ST. CHARLES
CATHOLIC CHURCH | CLARENDON

**ST. CHARLES BORROMEIO
CATHOLIC CHURCH**
CLARENDON SECTOR PLAN
PROPOSED CHANGES

November 18, 2020

Fairfax Drive Improvements

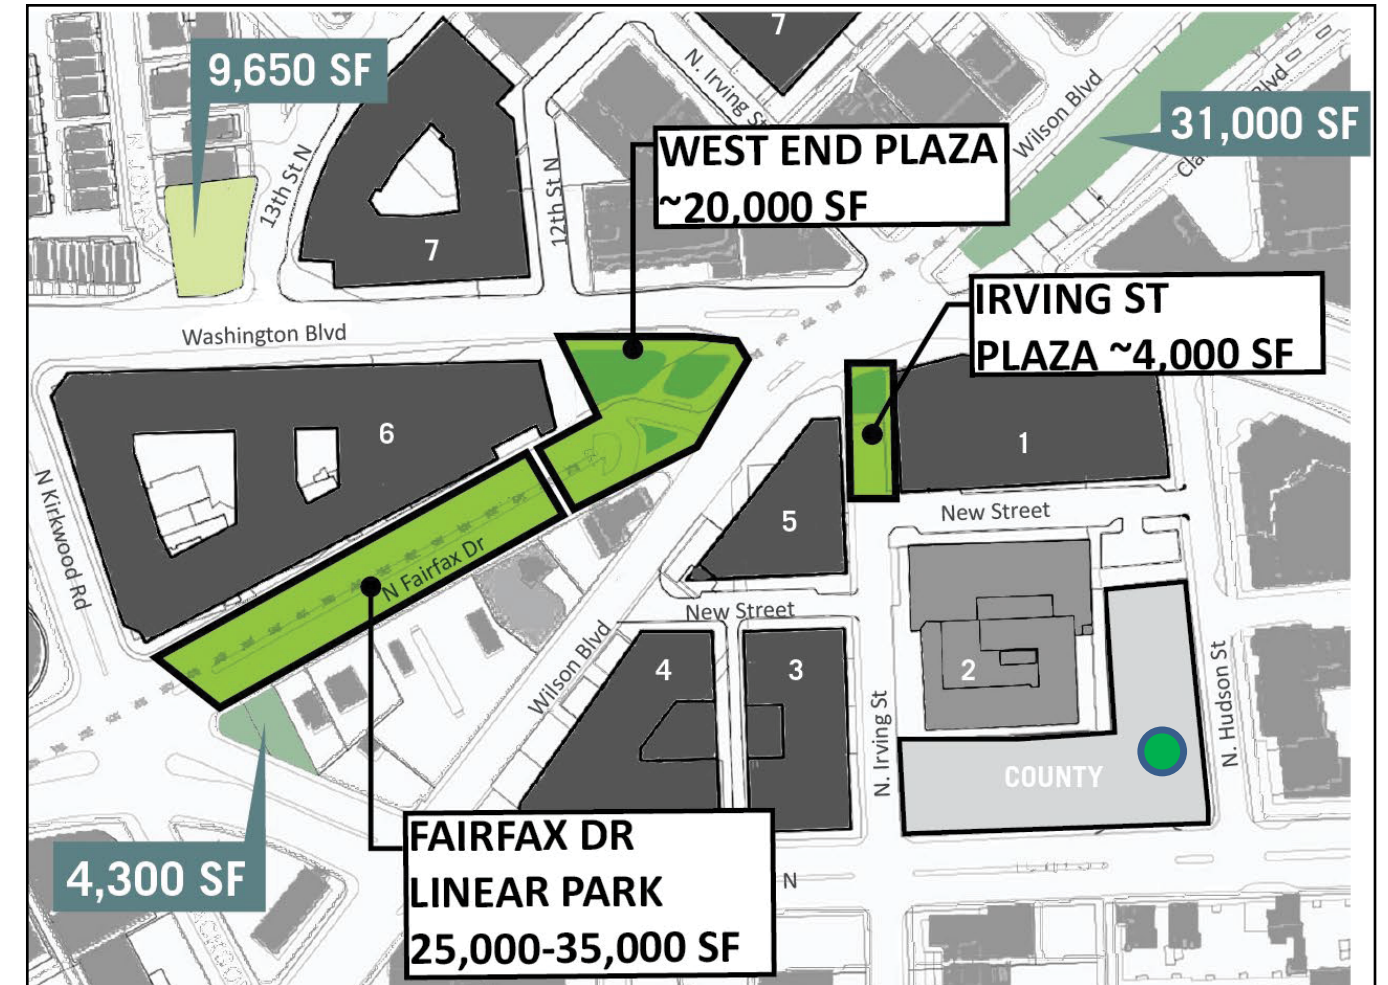
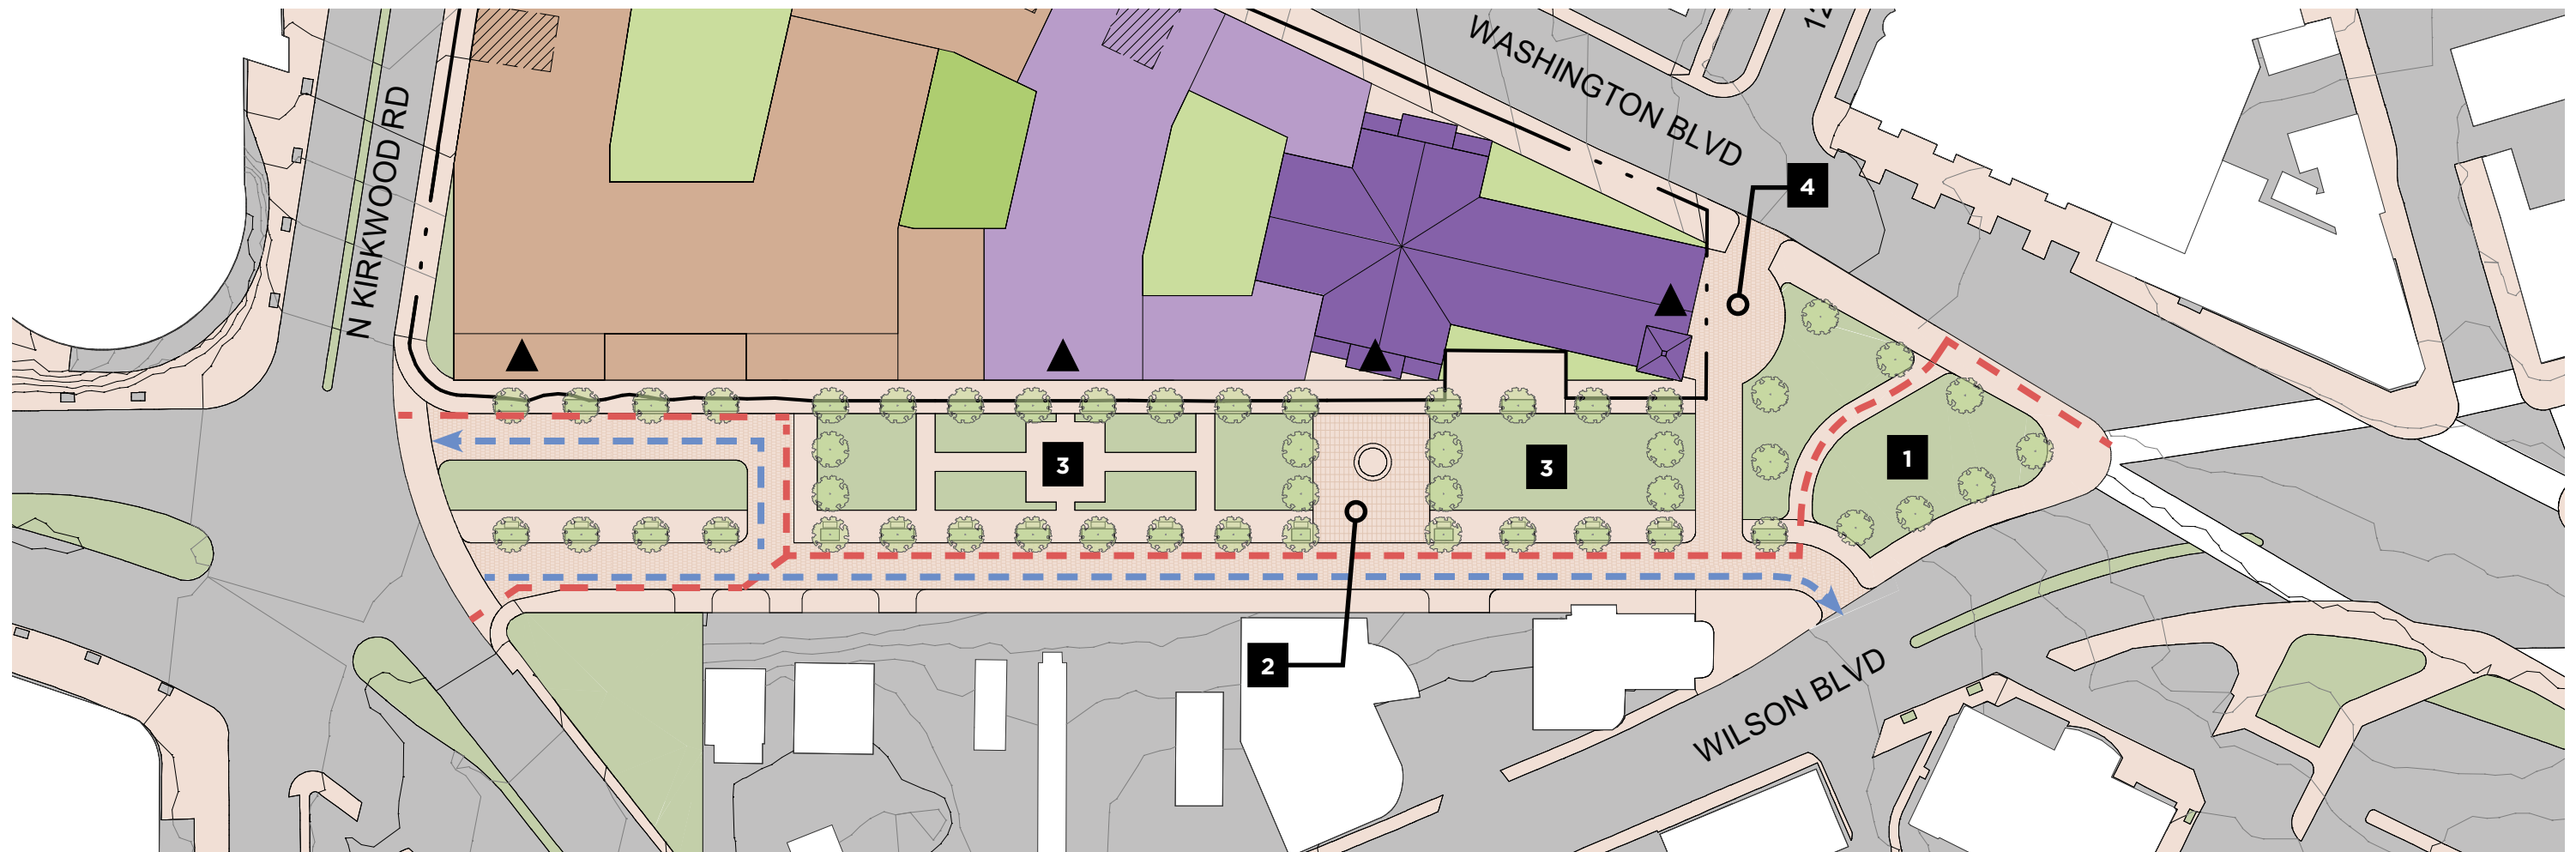
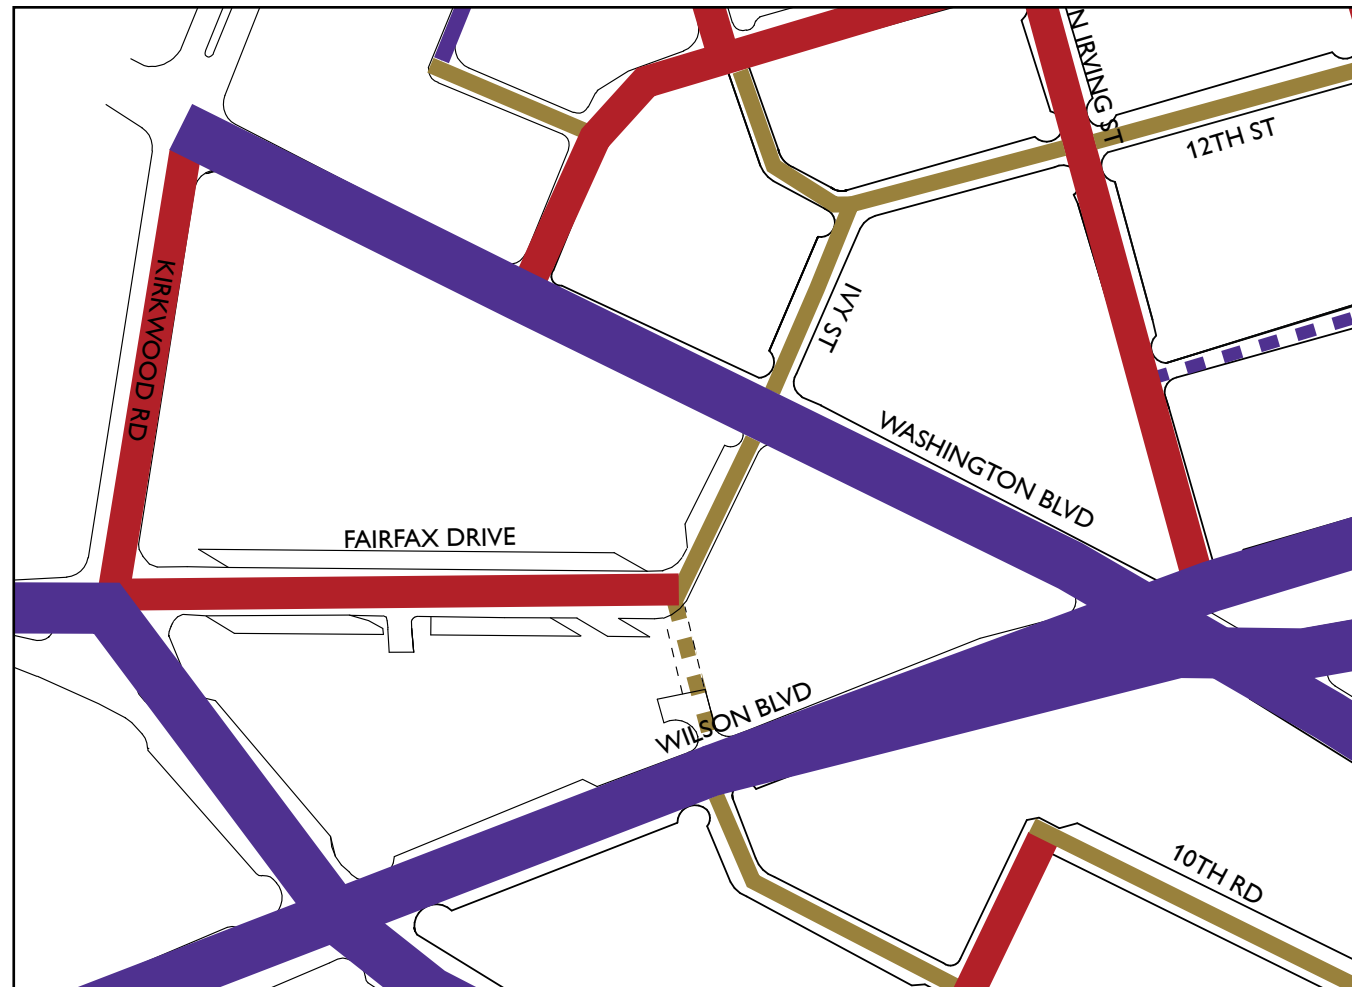
- Revise Fairfax Drive into a shared use pedestrian friendly plaza
- Provide paved pedestrian connection at future 12th St. Allow limited vehicular access.
- Reroute existing bike lanes along south side of plaza to reduce interaction with pedestrians.
- One way vehicular access along south side of Fairfax and at West end of park.

These proposed improvements create a beautiful open space for the community, complement envisioned the site redevelopment, offer limited vehicular access where necessary, and enhance pedestrian connectivity.

MAP 2.10: STREETS

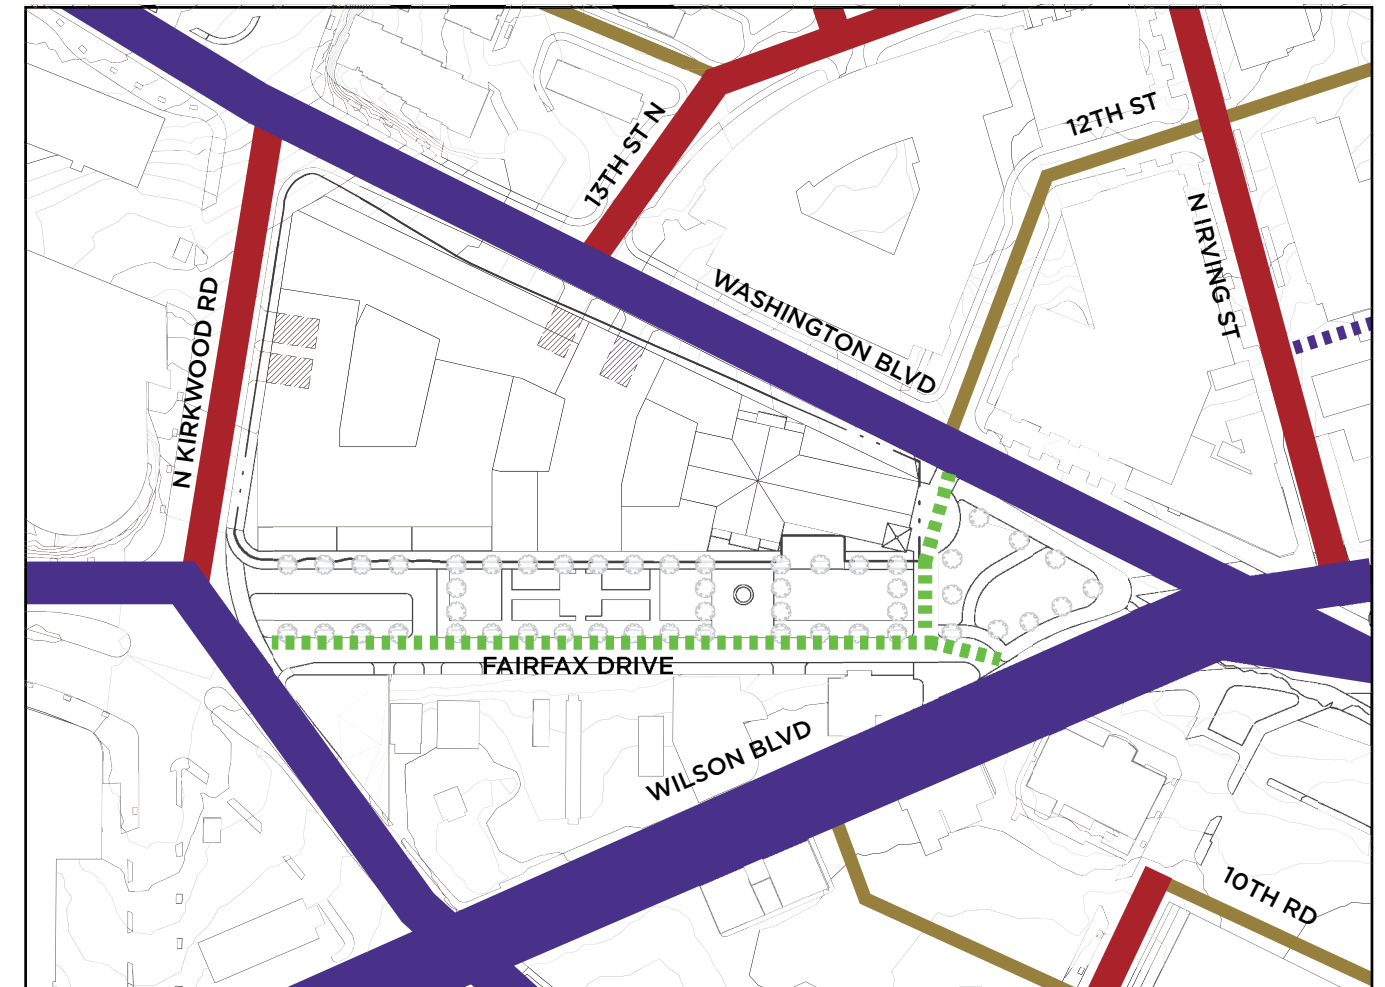
- Reclassify Fairfax Drive and N. Ivy St. as a pedestrian street with limited vehicular access.

The conversion of N. Ivy St into a primarily pedestrian path allows for a beautiful green space directly adjacent to the future St. Charles and maintains the option to connect with a future open space along Fairfax Drive.
